# ERL Comment Proposal Overview (r02-19 - r02-26)

Richard Mellitz, Samtec

**May 2018, Pittsburg, Pennsylvania**

IEEE 802.3 50 Gb/s, 100 Gb/s, and 200 Gb/s Ethernet Task Force

# Suggest Tx host ERL minimum 12 dB

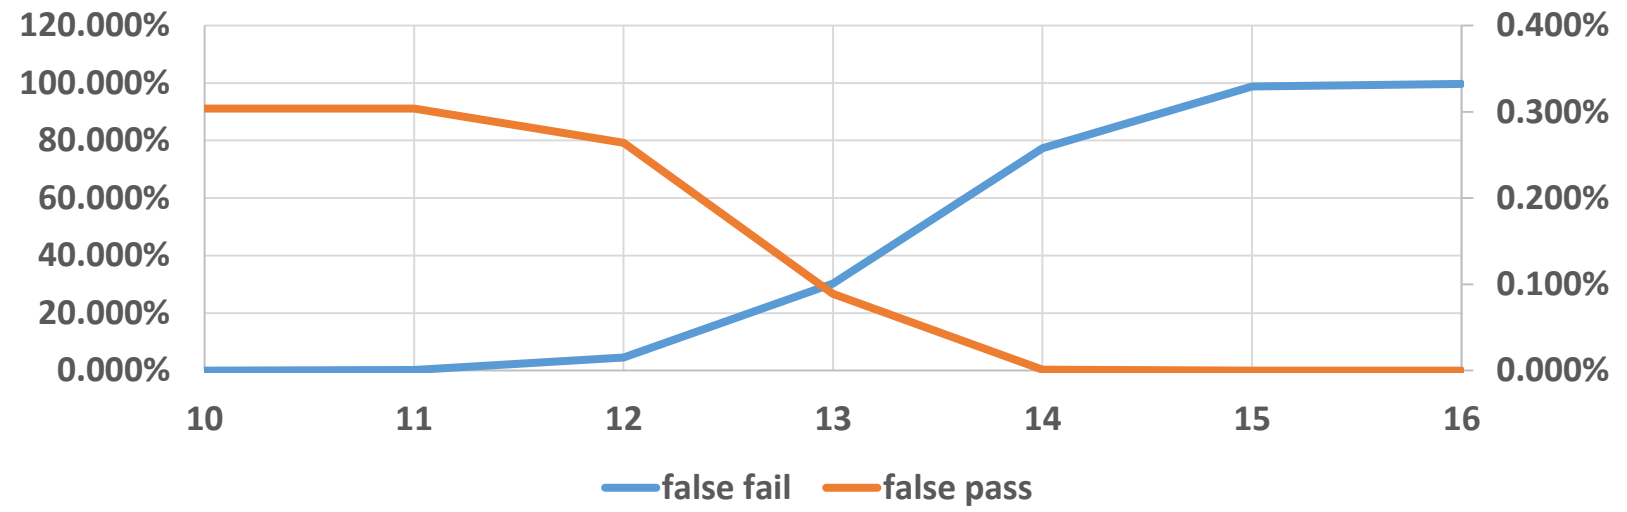
3 m cable		
ERL	false fail	false pass
10	0.001%	0.304%
11	0.175%	0.304%
12	4.569%	0.264%
13	30.265%	0.089%
14	77.336%	0.001%
15	98.754%	0.000%
16	99.696%	0.000%

Plotting on same scale could suggest Tx Host ERL min could be more like 10 dB or 11 dB

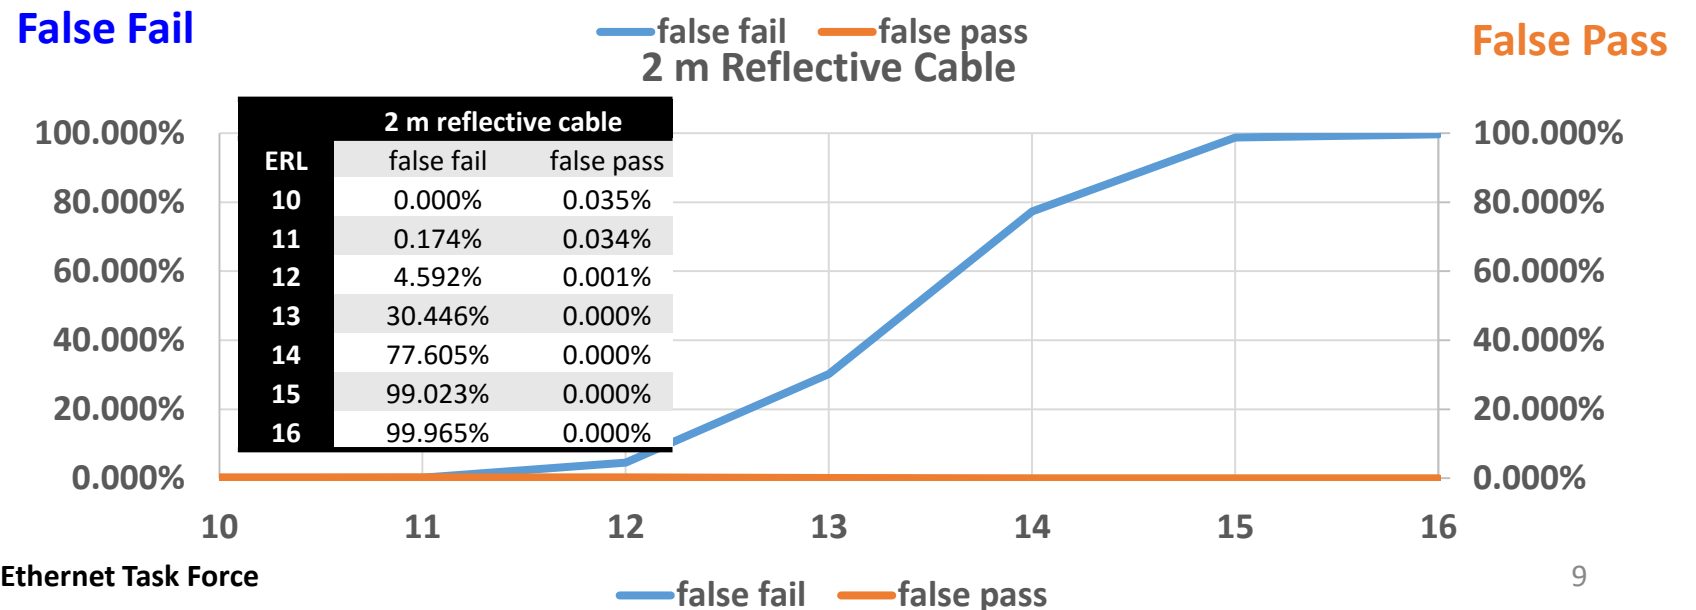
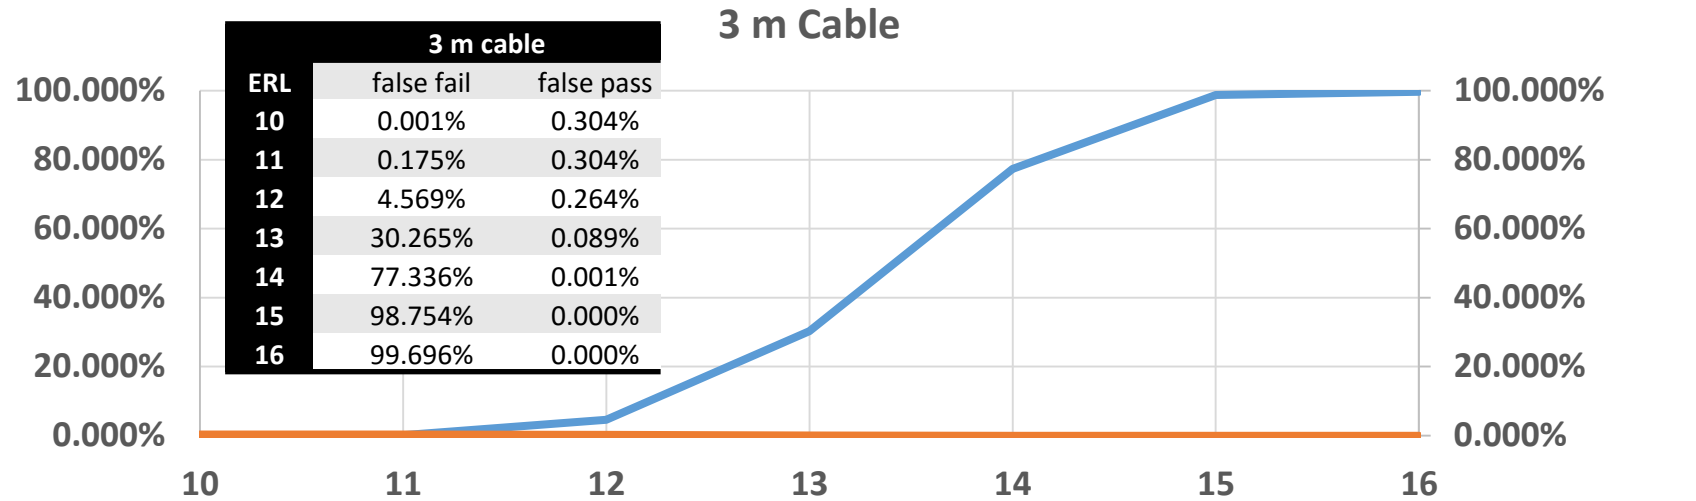
2 m reflective cable		
ERL	false fail	false pass
10	0.000%	0.035%
11	0.174%	0.034%
12	4.592%	0.001%
13	30.446%	0.000%
14	77.605%	0.000%
15	99.023%	0.000%
16	99.965%	0.000%

False fails seems like a much bigger problem
